**SUPERIOR CHARTER TOWNSHIP
ZONING BOARD OF APPEALS
3040 N. PROSPECT RD., YPSILANTI, MI 48198**

**WEDNESDAY
AUGUST 3, 2022
7:00 P.M.
AGENDA**

**SUPERIOR CHARTER TOWNSHIP
ZONING BOARD OF APPEALS
DRAFT MINUTES
MARCH 30, 2022
PAGE 1 of 9**

"60' easement setback line" including easement on Schuster property

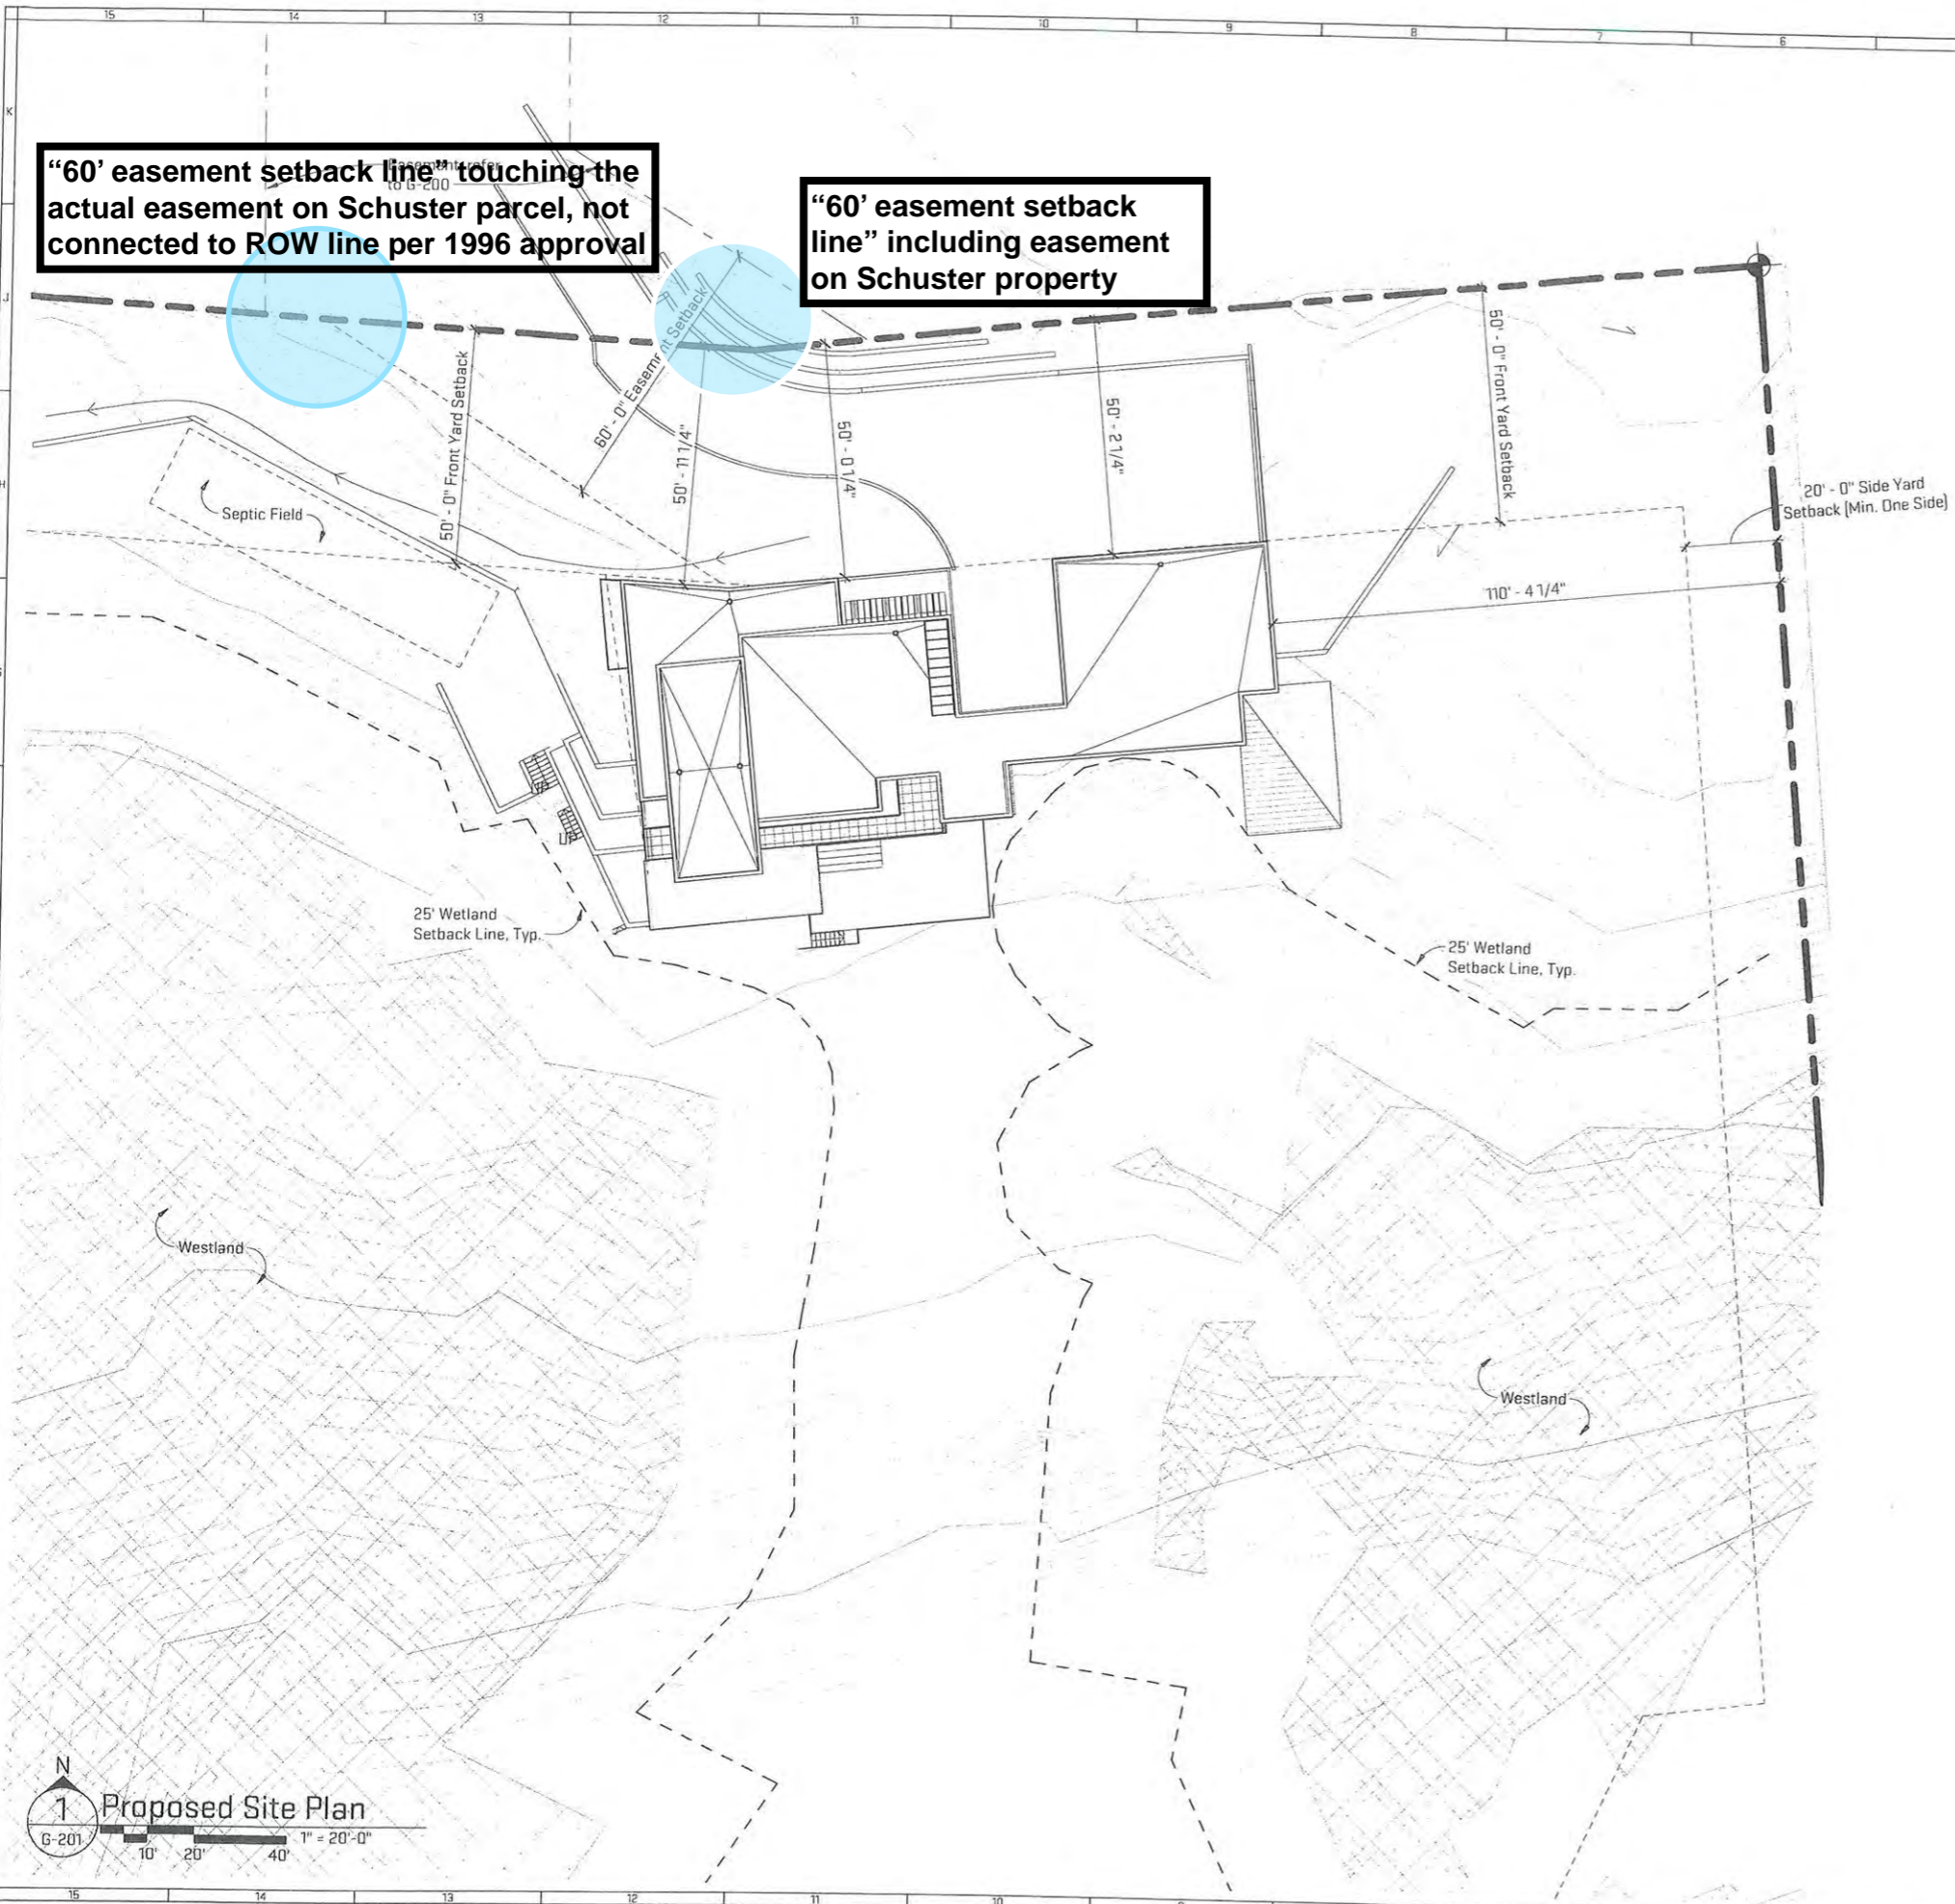
Sheet G-201 shows the private road easement and the required 60' setback. The proposed building does not encroach into the setback.
2	<i>The submitted site plan (sheet G-201) is not adequate. The private road easement is not illustrated. The limits of the wetlands are not illustrated. Grading elevations and storm water management elements are not shown. Specific locations, heights and designs of site retaining walls are not shown on the site plan nor elsewhere on the plans.</i>
	Additional information was added to sheet G-201. Sheets G-200 (Existing Site Plan) and L-2 (Grading Plan) were added to show the existing site including the private road easement and extents of wetland. Sheet L-2 shows grading on the site and storm water management elements.
3	<i>Sheets G-100 and G-201 indicate conflicting home and garage square footage - which is correct?</i>
	Square footage has been confirmed and corrected between sheets.

4	<i>Notes on sheet S-012 indicated "construction surcharge on retaining wall to be determined." Who will be determining the surcharge if not the engineer?</i>

Sheet S-012 has been updated with the construction surcharge information.
5	<i>Plans do not indicate specific steel beam sizing, footing sizing and foundation wall sizing and reinforcement (other than "typical" details) for the home or for site retaining walls.</i>

"60' easement setback line" touching the actual easement on Schuster parcel, not connected to ROW line per 1996 approval
